TOWN OF MONUMENT - WATERLINE AND STORAGE TANK SITE DEVELOPMENT PLANS LOT 6, FOREST VIEW ESTATES FILING NO. 4

PCD FILE NO. **PDR-21-030**

PROJECT NO.	04-20-0153	BY	DATE
	DRAWN	S. CALE	REVISIONS	
	DESIGNED	J. ADAMS	NO.	
	APPROVED	J. ADAMS	This document or any part thereof in detail or design shall not be used for any project without the written authorization of Forsgren Associates Inc.	
PROJECT NO.		56 INVERNESS DRIVE EAST #112, ENGLEWOOD, CO 80112		PH: 720.232.6644
2.0M GALLON TANK GRADING AND EROSION CONTROL PLAN		SHEET NO. 1		
DATE:		JAN, 2022		
PAGE NO.:

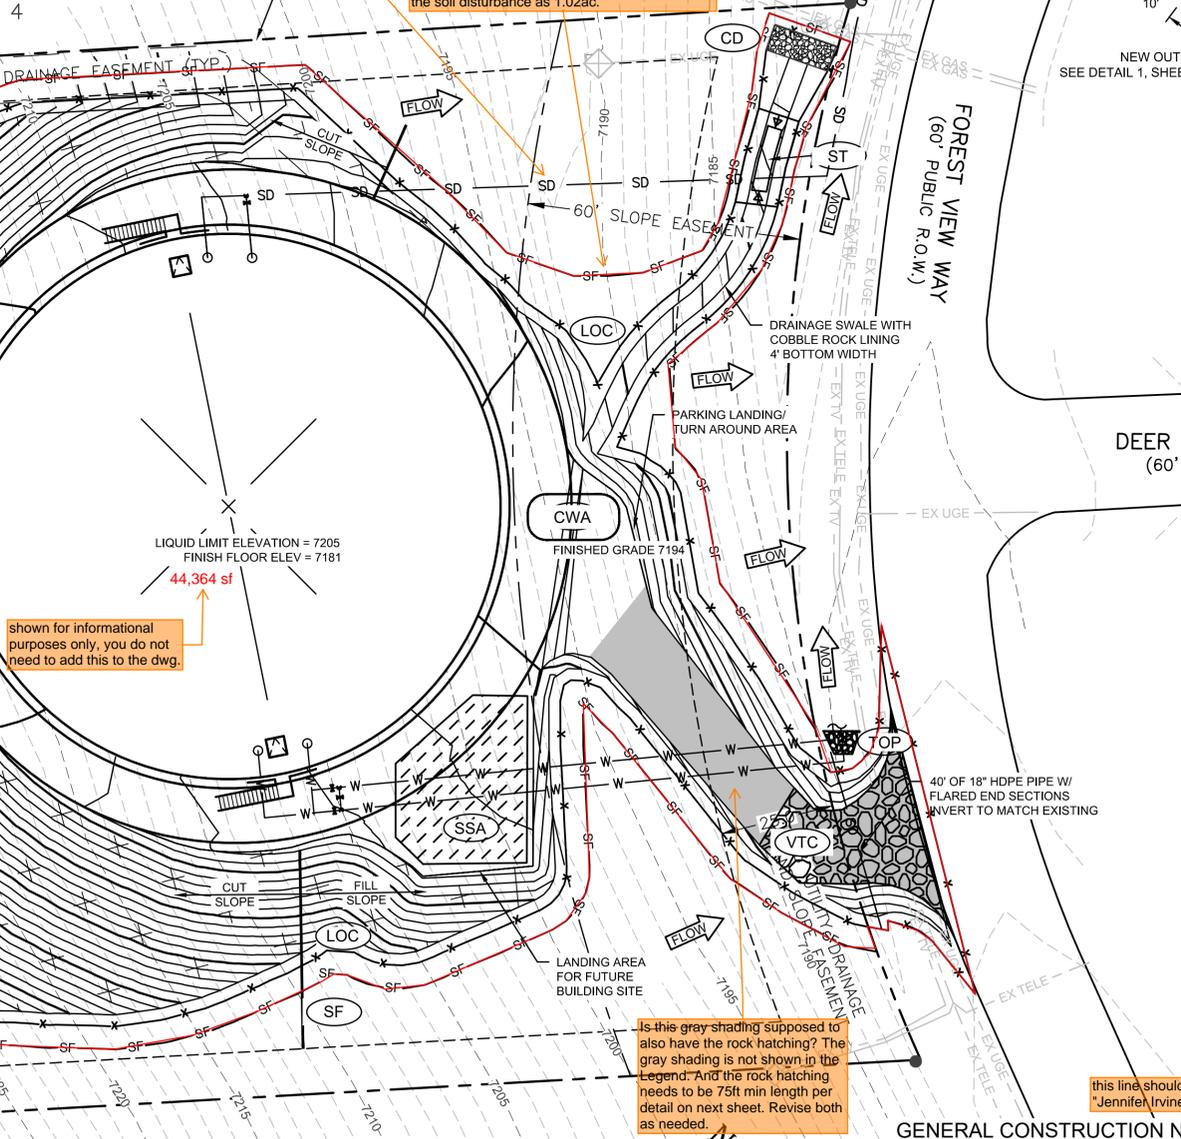
Unresolved comment from Review 1:
Items H and M. If "limits of disturbance" and "construction boundary" are the same, change to "limits of construction/disturbance" or otherwise show as separate linetypes for each on the legend and figure.

There is soil disturbance involved with installation and maintenance of SF. Revise drawing to show LOC outside of SF. I know that the layout of BMPs is graphical in nature and that the LOC and SF are likely to have the same perimeter. But since the area of soil disturbance is so close to 1ac, it would be good to show a more exact LOC. The current outline of the SF shows the soil disturbance as 1.02ac.

Unresolved comments from Review 1:
- Checklist item "i" - make note of existing condition of vegetation (type of vegetation and estimated % coverage)
- Checklist item "p" - label/delineate areas of cut/fill (a note would be acceptable too, for example: "site is predominately cut on the southern half and...")

Is this gray shading supposed to also have the rock hatching? The gray shading is not shown in the legend. And the rock hatching needs to be 75ft min length per detail on next sheet. Revise both as needed.

this line should be below Jennifer Irvine

Revise to: 'PPR'

GEC Plan must include entire length of pipeline (at an acceptable scale per item C on the checklist) to show seeding and mulching along the line, inlet protection, check dams in the roadside ditch, etc. This is standard for all UG utility projects like this. And address these BMPs associated with the pipeline in the SWMP text.
